Park District of Highland Park

2023 Cunniff Park Pickleball Courts Fencing Improvements Project

ADDENDUM # 1

February 17, 2023

DRAWING TITLE:
Proposed Layout Plan/Details

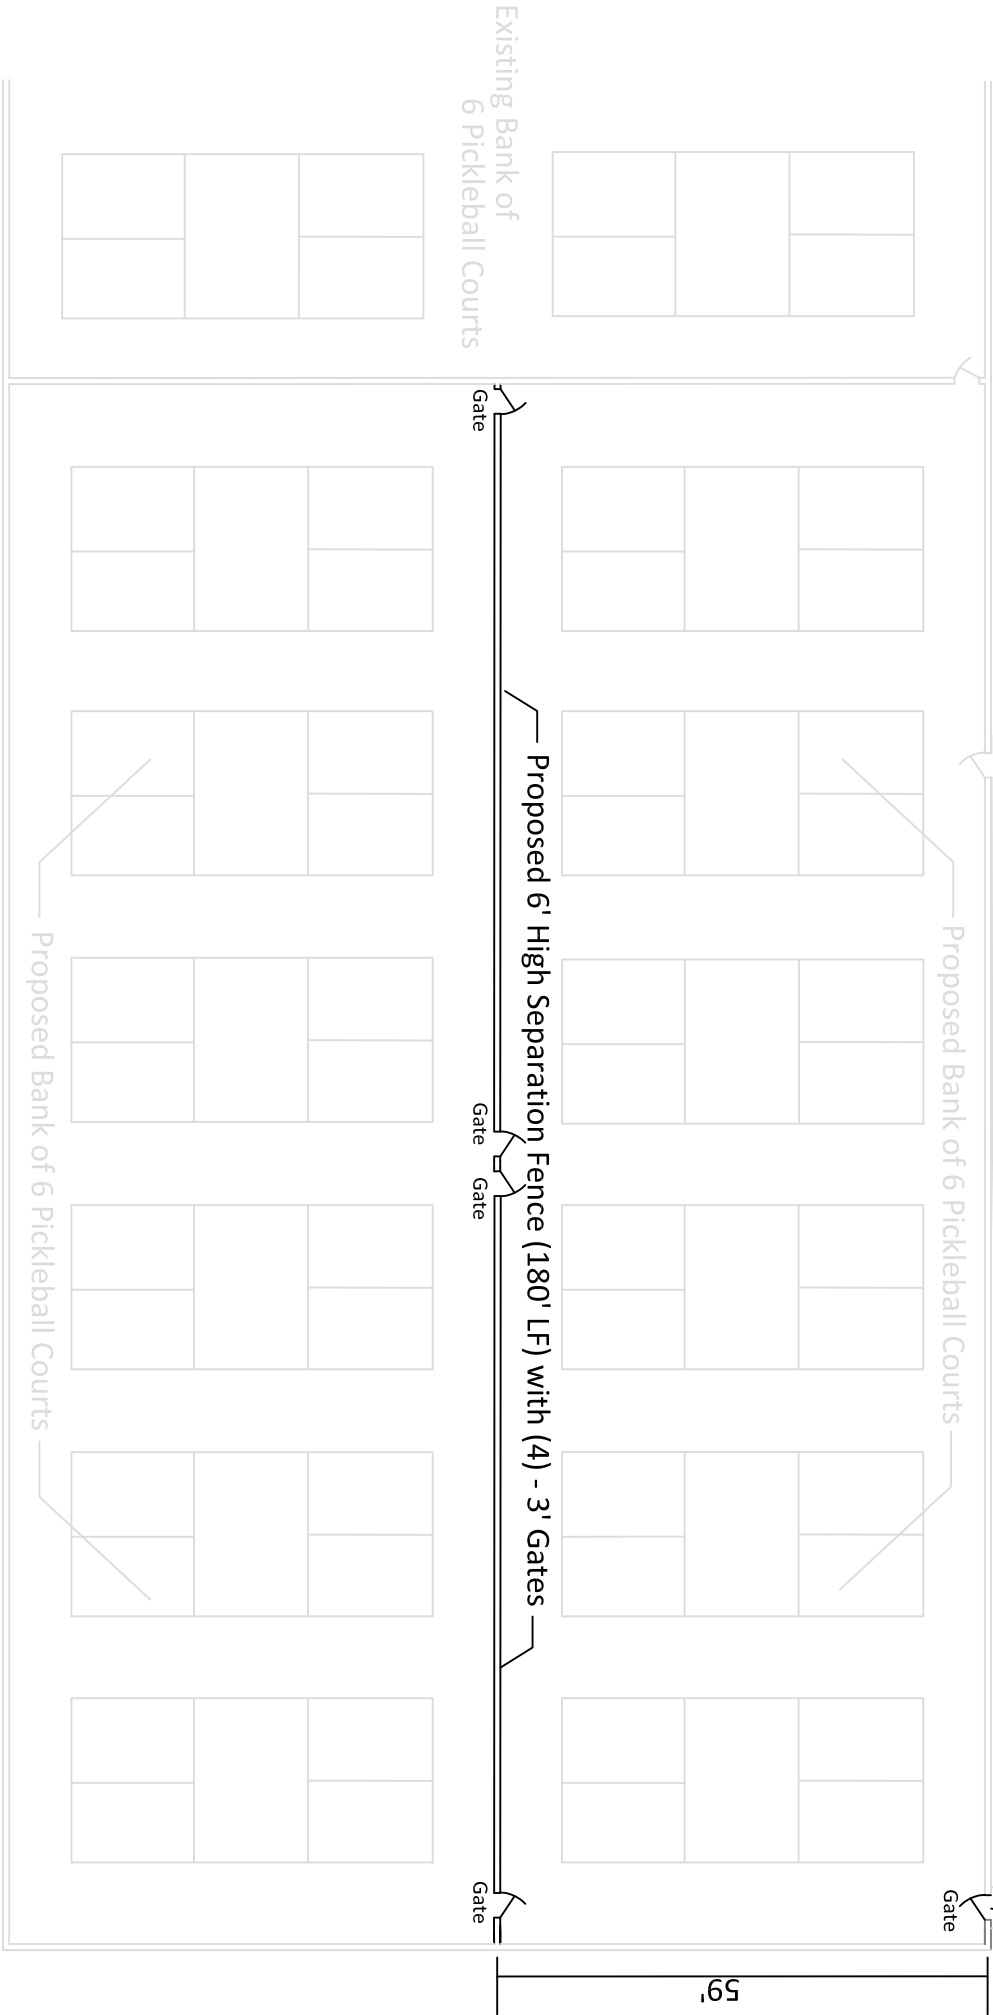
Item # 1 – The Proposer shall furnish and install 180 LF of separation 6’ high black chain link fence (180’ LF) at 6’ OC, (4) – 3’ gates, (1) – 3’ entrance walk gate and readjustments to existing perimeter fence to accommodate new gate. (No proposed separation fencing shall be at 10’ OC. as was in previous plan.

Add 3' gate to existing fence
